MacLellan's Castle
Signage schedule for replacing external panels
2015-16

3.0 Phase 1 signage schedule

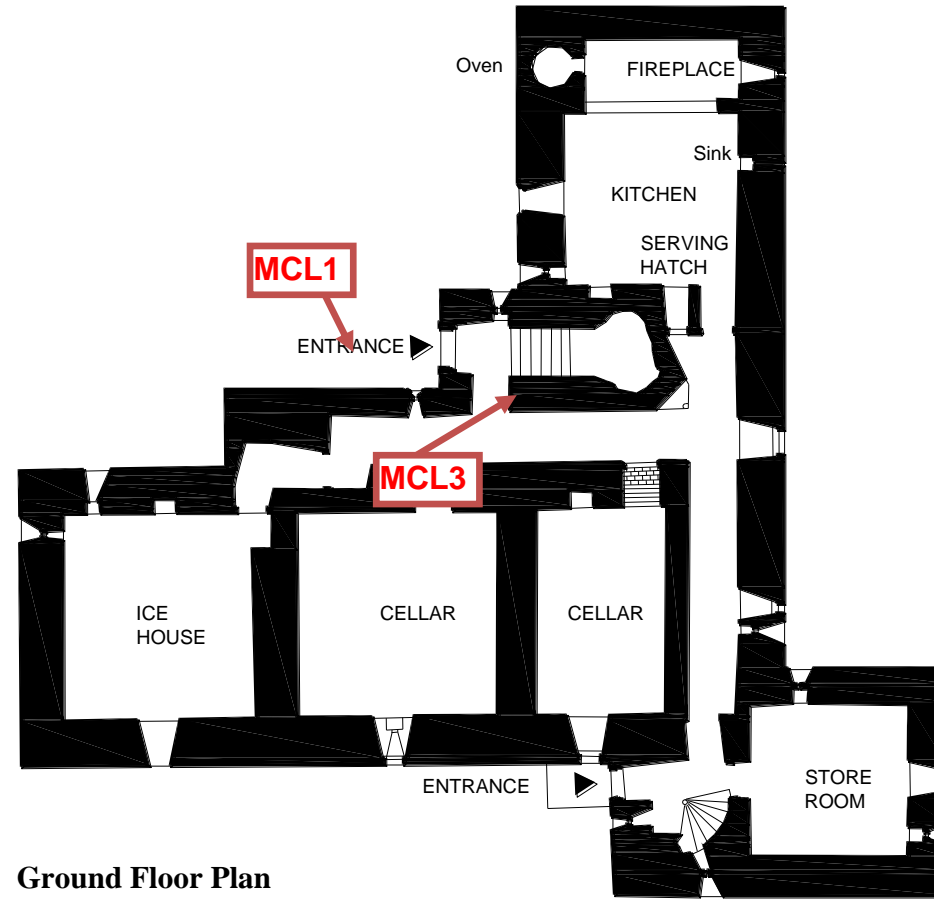
| Code | Location | Type & size | Fixings | Location shot |
|------|--------------------------------|---|--|--|
| MCL1 | Replace panel at main entrance | A1, W3J panel to fit onto existing stand. | <p>None. Panel will be fixed to the existing stand.</p> <p>N.B. We understand this panel may not require consent but it is included for information at this stage.</p> <p>CNR Comments:</p> <p>As per discussion with John Malcolm, this panel does not require SMC. There are no archaeological or setting implications to the replacement of this panel. CNR are content with the replacement.</p> |   |

| MCL2 | Replace existing wall-mounted panel in Great Hall | A1, W3J panel to be wall-mounted. | <p>Panel will be wall-mounted into mortar joints.</p> <p>CNR Comments:</p> <p>The replacement panel will use existing fixings if possible. If new fixings are required they will be into mortar joints. The new panel will not cover any architectural features that are of significance in understanding the use, history or development of the monument. CNR are content with this panel.</p> |  |
| MCL3 | Remove panel just inside main entrance to the castle. Content will be included elsewhere. | NA | <p>NA</p> <p>CNR Comments:</p> <p>The removal of this panel and making good of fixing holes has no significant implications from an archaeological or setting point of view. The impact on the fabric of the monument is very minimal. CNR are content with the removal of this panel.</p> |  |
